| rtoloodod: 10 l | 00 00 | | | | |
|--|---------------------------|-----------------|-------------------------|----------------------|--|
| Model: Campa | ri-MF1L | D | ate: 04-Oct-06 | No.: G959001b | |
| Subject: Firmwar | re Release History(Engine | Prepared by: T. | Prepared by: T.Shintani | | |

| Model: Campari-MF1L | | | Dat | Date: 27-Mar-07 | | No.: RG959002 |
| Subject: Countermeasure for Machine stall problem | | | Prepared | d by: T. S | Shintani | |

| Model: CM-C1L | | | Date: 21-Aug-09 | | -09 | No.: RG959004 |
|---------------------------------------|--------------------------------|--------------------|-----------------|------------|-------|----------------------------------|
| Subject: Exit Roller (Frame Assembly) | | | Prepare | d by: Y. C | Gaman | |

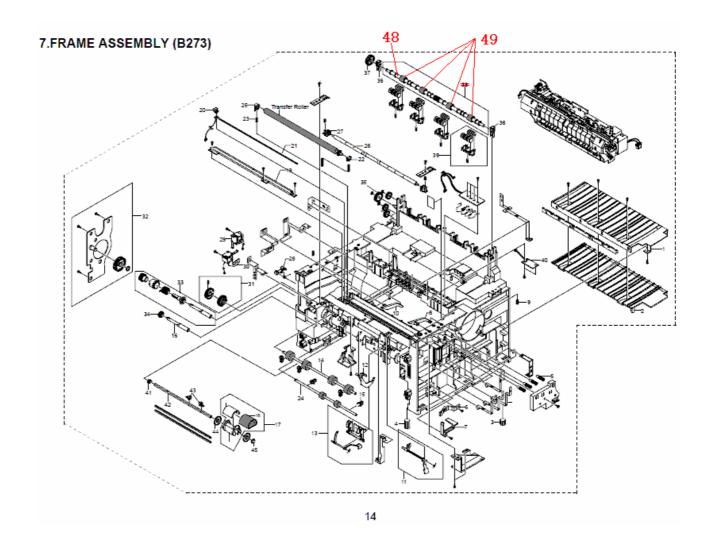
Change: The assembly in the table below (P/N H9149725) was divided into two parts.

Reason: The Parts Catalog was corrected.

| Old Part Number | New Part Number | Description | Q'ty | Int | Page | Index | Note |
|--------------------|--------------------|------------------|------|-------|------|-------|------|
| H9149725 | H9149725 | EXIT ROLLER POLE | 1 | 0/0 | 14 | 38→48 | |
| 119149723 | G1449752 | EXIT ROLLER | 4 | . 0/0 | 14 | 38→49 | |

8.FUSING UNIT ASSEMBLY (B273)

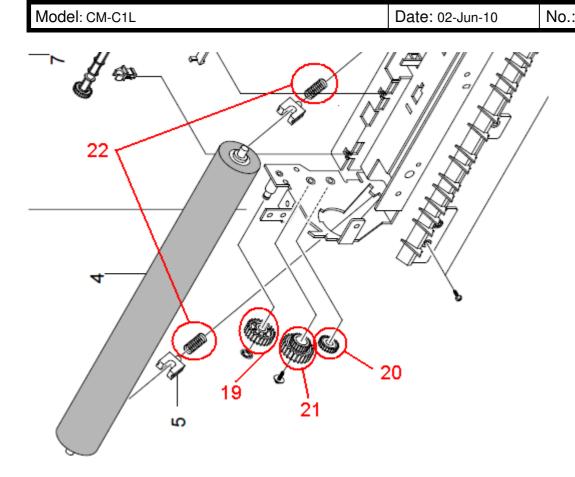
Change: The following service parts are added.

Requests from the field.

| New Part # | Description | Q'ty | Page | Index | Note |
|------------|----------------------------|------|------|-------|------|
| G9601101 | IDEAL GEAR MA ASS'Y (RoHs) | 1 | 17 | 19 | |
| B1739804 | GEAR DRIVE16 | 1 | 17 | 20 | |
| G1449609 | GEAR 25/15 | 1 | 17 | 21 | |
| G1449729 | SPRING - BEARING | 2 | 17 | 22 | |
